MILITARY SPECIFICATION

HOSE AND FITTINGS, OIL AND TURBINE FUEL, SMOOTH BORE, CORRUGATED COVER, 7-INCH

This amendment forms a part of MIL-H-24565(SH), dated 3 March 1978, and is approved for use within the Naval Sea Systems Command, Department of the Navy and is available for use by all Departments and Agencies of the Department of Defense.

FIGURE 1. Convolution details of hose carcass.

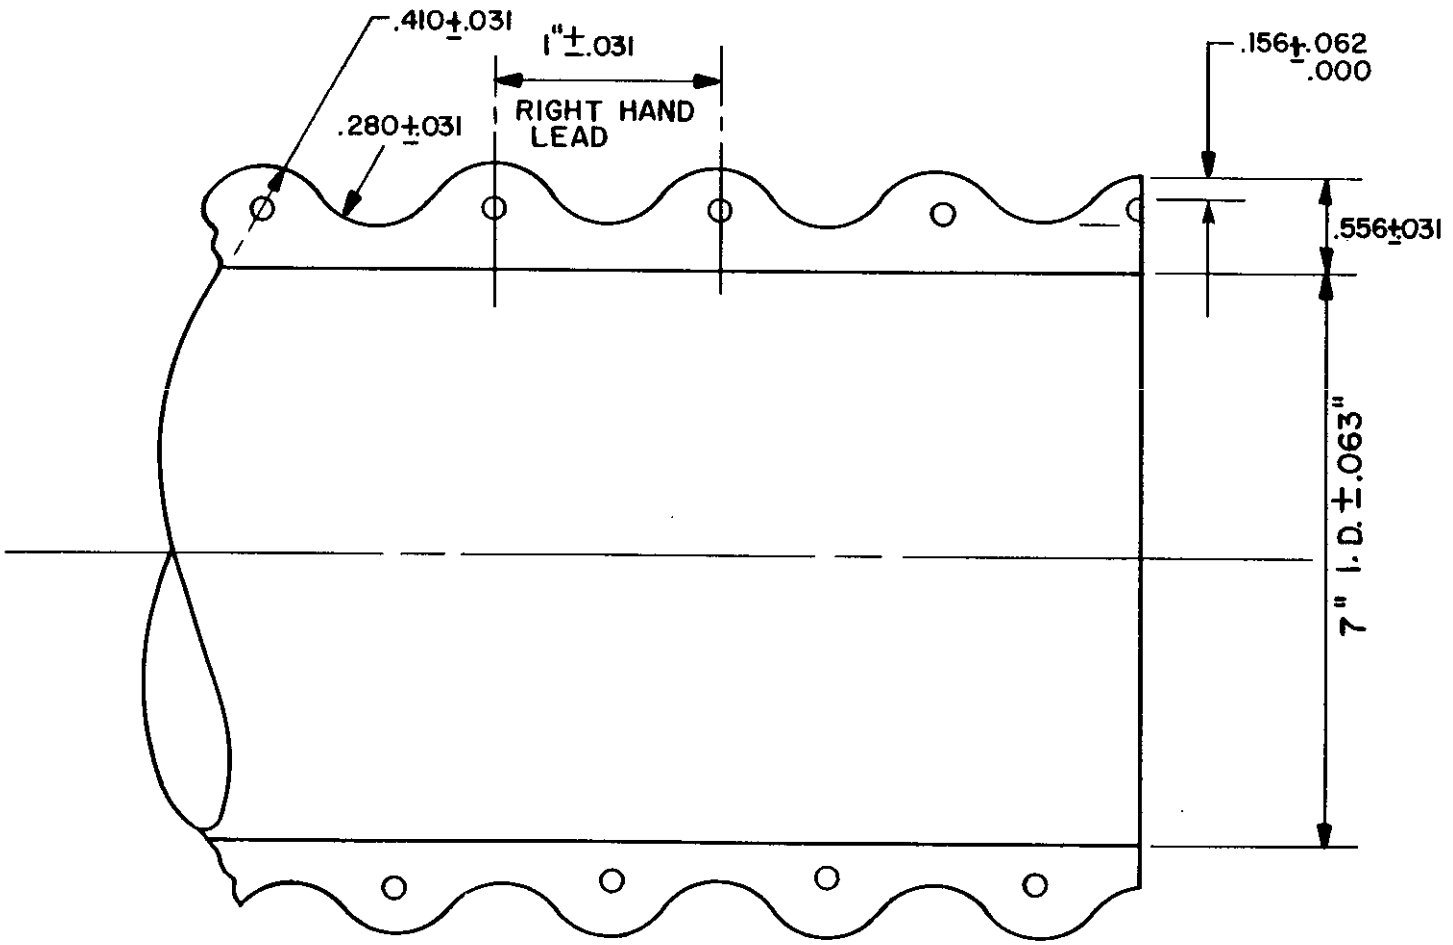
FIGURE 1: Delete in its entirety and substitute new Figure 1.

FIGURE 2. Reattachable coupling.

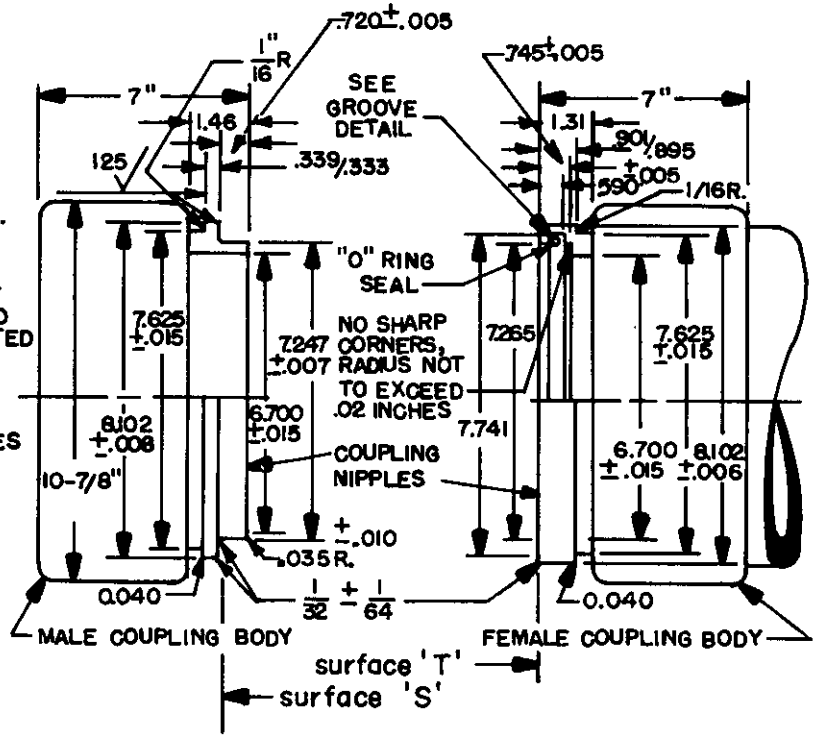
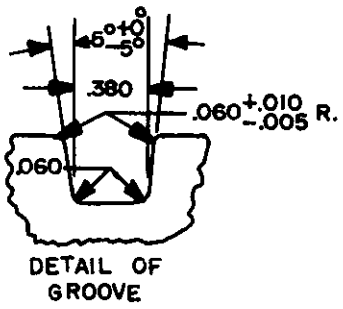
FIGURE 2: Delete in its entirety and substitute new Figure 2.

FIGURE 3. Split clamp.

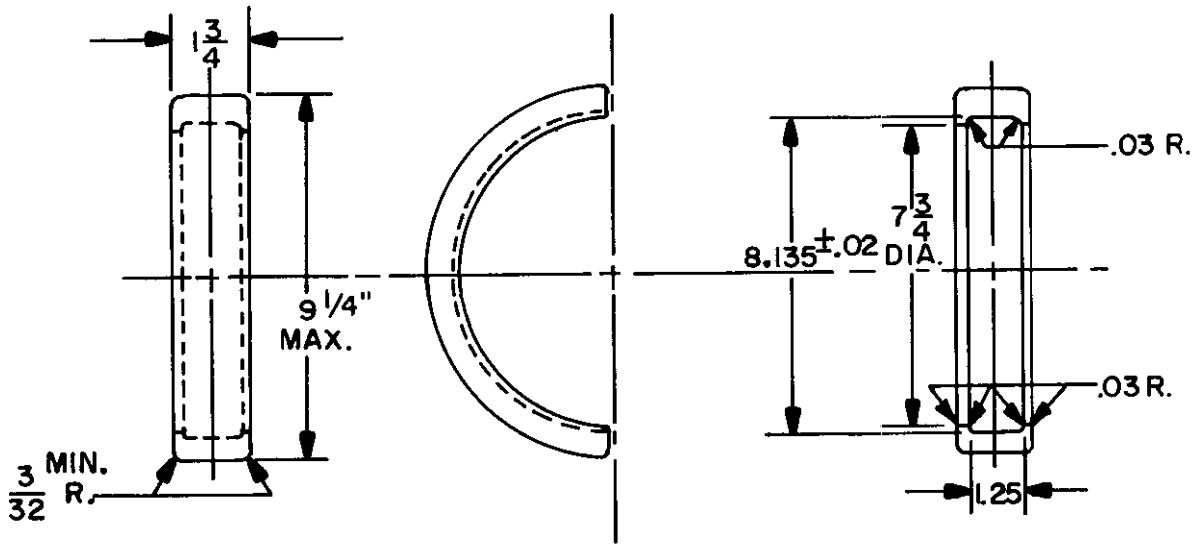
FIGURE 3: Delete in its entirety and substitute new Figure 3.
